5. Development Permit with Variance Application No. 00011 for 2330 Richmond Road

5.2 Development Permit with Variance Application No. 00011 for 2330 Richmond Road

Committee received a report dated November 18, 2016, from the Director of Sustainable Planning and Community Development regarding an application to construct a three-storey, seven-unit, multi-family development.

== PAGE TITLE ==
SITE / LAYOUT / DETAIL PLANE PAGE 2 OF 3

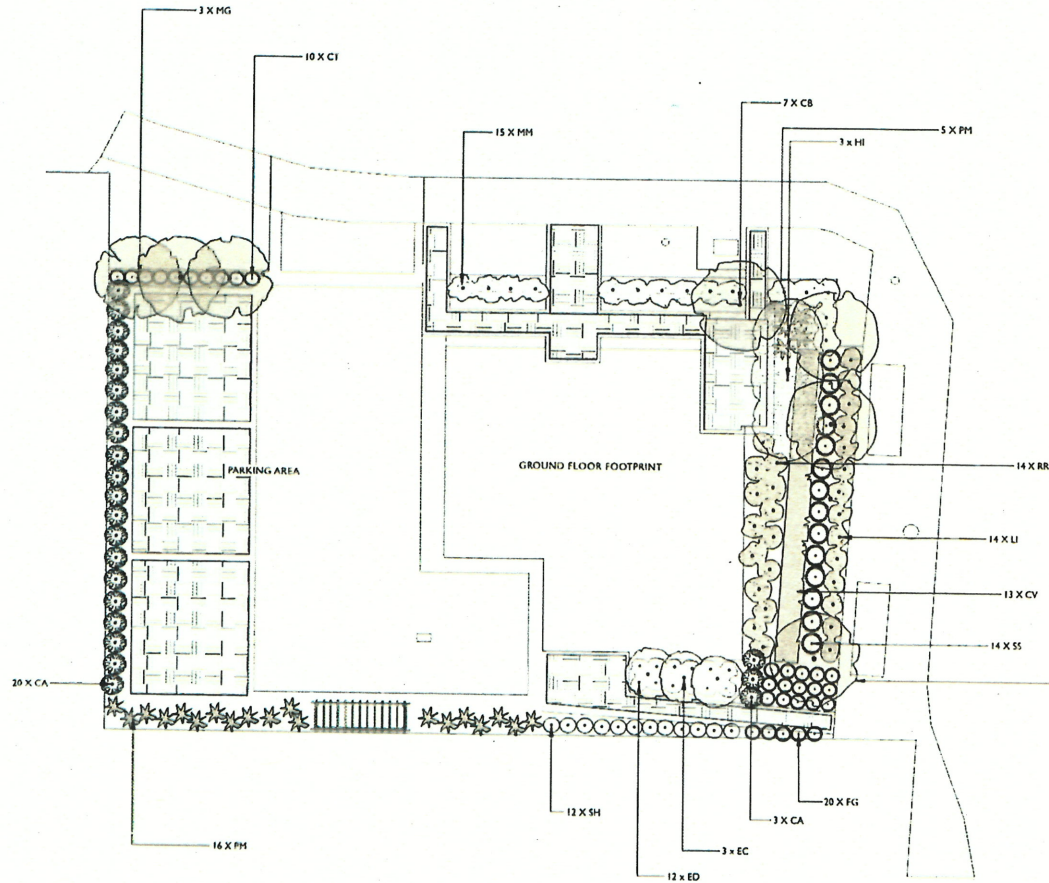
- A suggestion to pull back the concrete sidewalk from the building edge and add some landscaping to help soften the perimeter on the Bay Street side.
- How the overall landscape design is not creating the right buffer from the building to street and it was suggested to reconsider the punctuation of the trees to correspond better with the rhythm of the building.

HORNBEAM TREES WILL BE PLANTED TO REFLECT RHYTHM OF BUILDING AS SHOWN IN EAST ELEVATION ON PAGE ONE OF THIS DOCUMENT
